Access Compliance Report

Public Rights-of-Way

Intersection ID: 30214	Main Street: HIDDEN_CREEK_DR	Cross Street: MOSS_STREAM_LN	Location:	N
ADA ID: CEF7C6C13055	Ramp Type: Perp	Initial Pass/Fail: Pass	Overall Compliance: No	Severity Score: 14
Codes/Mitigation Info/Possible Solution		Field Measurements/Component Compliance

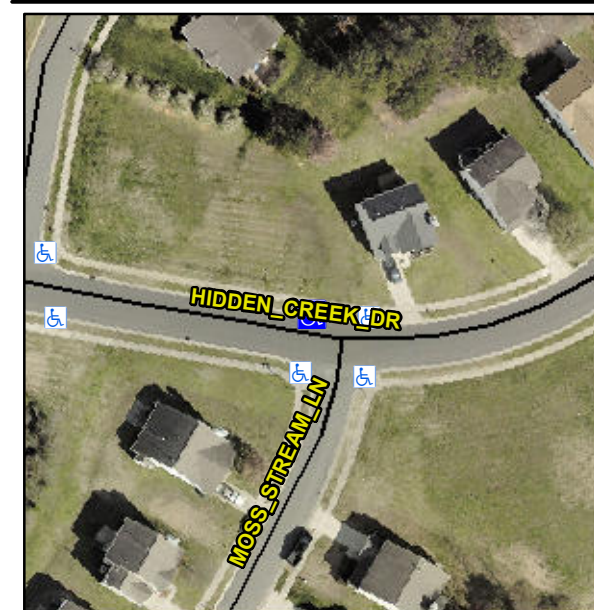
**Not Found, R304.2.1, R304.2.2-Perp,
R304.3.2-Para, R305, R302.3, R402.2**

Compliance	Description	Data	Compliance	Description	Data
N/A	Ramp Length (in)	48.0	Yes	Ramp Slope (%)	5.9
Yes	Ramp Width (in)	52.0	Yes	Ramp XSlope (%)	1.7
N/A	Flare Type LT	Sloped	N/A	Flare Type RT	N/A
N/A	Flare Slope LT (%)	1.5	N/A	Flare Slope RT (%)	3.8
N/A	Flare Traversable LT?	No	N/A	Flare Traversable RT?	No
No	Landing Length (in)	43.5	No	DWS Provided?	No
No	Landing Width (in)	42.0	N/A	DWS Contrast?	No
No	Landing Slope (%)	2.3	N/A	DWS Length (in)	N/A
Yes	Landing X Slope (%)	0.6	N/A	DWS Full Width?	No
N/A	Landing Curb? (Y/N)	No	N/A	DWS Offset (in)	N/A
N/A	Shared Landing?	No			
Yes	Gutter Ponding?	No	Yes	Gutter Slope (%)	0.4
Yes	Gutter Lip Ht (in)	0.0	Yes	Gutter X Slope (%)	0.9
N/A	Painted X Walk1?	No	N/A	Painted X Walk2?	N/A
	X Walk 1 Direction	To S		X Walk 2 Direction	N/A
N/A	X Walk 1 Width (in)	N/A	N/A	X Walk 2 Width (in)	N/A
	X Walk 1 Slope (%)	1.0		X Walk 2 Slope (%)	N/A
	X Walk 1 X Slope (%)	2.4		X Walk 2 X Slope (%)	N/A

N/A	Ramp inside XWalk1?	N/A	N/A	Ramp inside XWalk2?	N/A
	Road Slope (%)	N/A	N/A	Clear Space?	Yes
	Road X Slope (%)	N/A	N/A	Clear Space to XWalk (in)	N/A
Yes	Any Obstructions?	Yes	Yes	Storm Grate/Utility Hazard?	No
	Obstruction Type			Storm Grate/Utility Type	
				WATER METER LIP 0.5	N/A
			Yes	Surface Condition? (G/P)	Good

**Remove & Replace Entire Ramp.
Utility Present.**
